SAN ANTONIO WATER SYSTEM Dos Rios Water Recycling Center (DRWRC) Digester Mixing and System Enhancements, Phase II SAWS Job No. 11-6502

Solicitation No. B-13-043-MF

ADDENDUM NO. 2

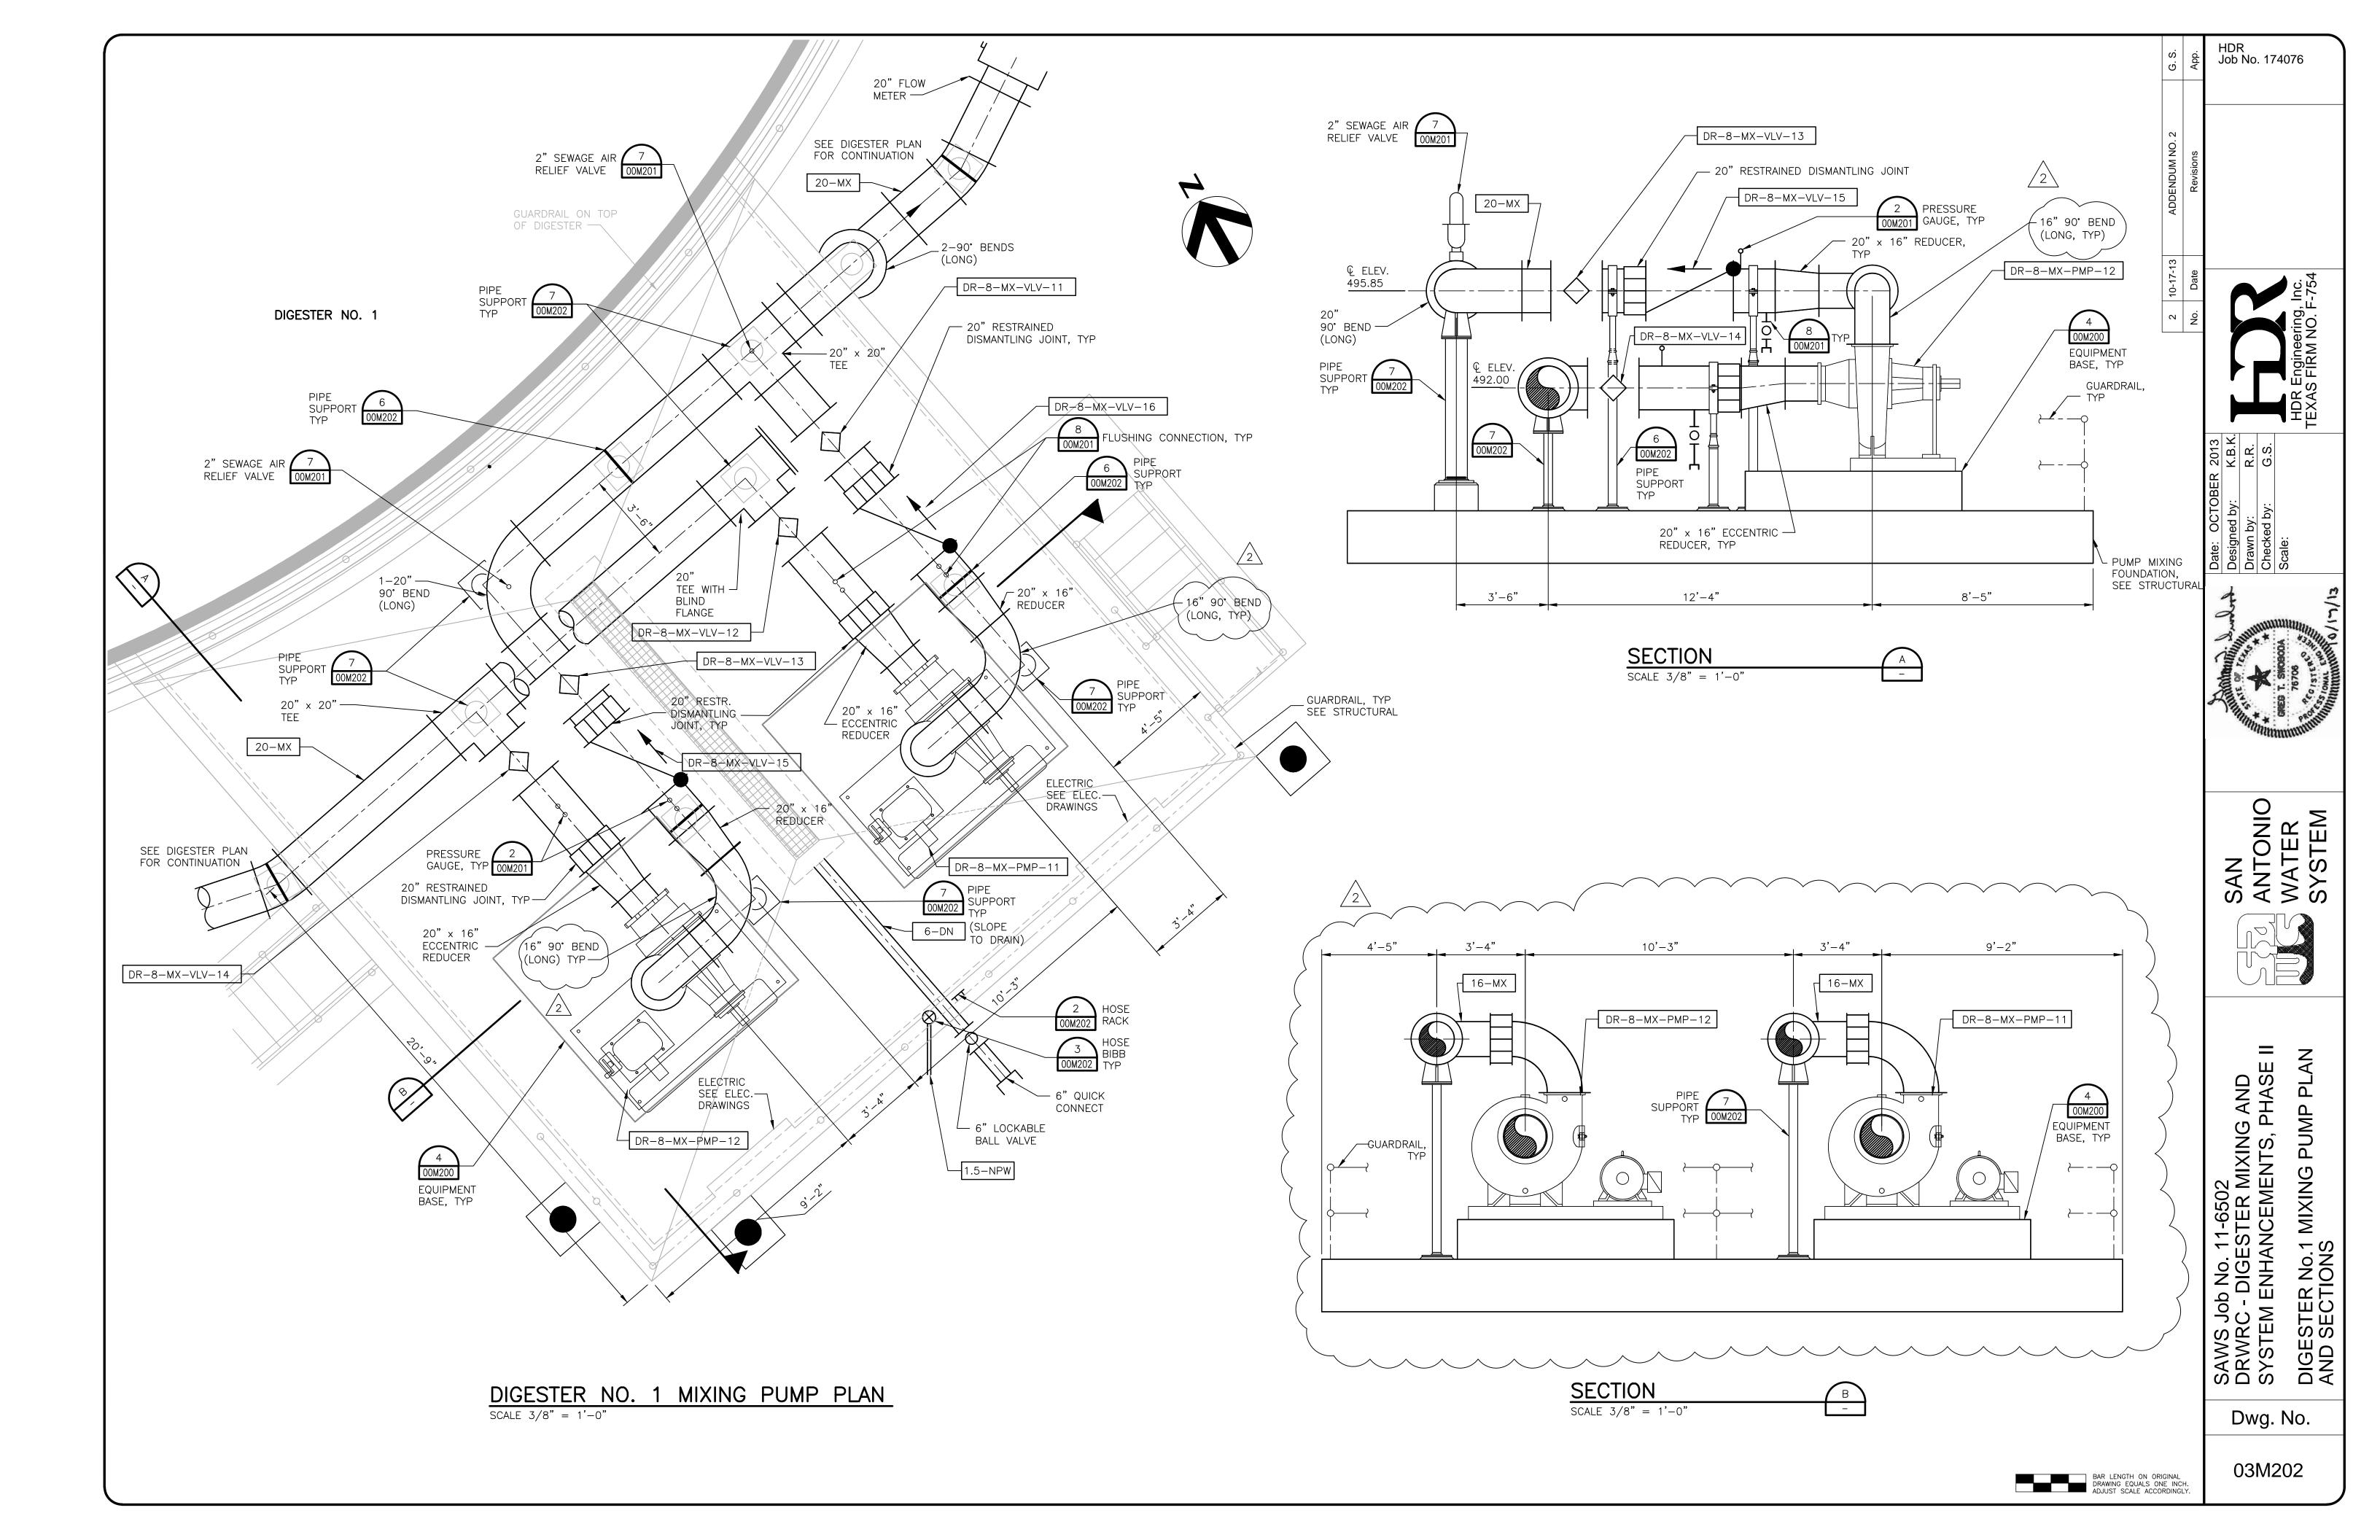
- a. Add General Note No. 4. "4. Contractor shall field verify pipe size and material prior to ordering materials for connecting to existing piping."
- 3. Drawing No. 03M202
 - a. For modifications to this drawing, refer to attached Drawing 03M202.
- 4. Drawing No. 03M203
 - a. For modifications to this drawing, refer to attached Drawing 03M203.
- 5. Drawing No. 03M204
 - a. For modifications to this drawing, refer to attached Drawing 03M204.
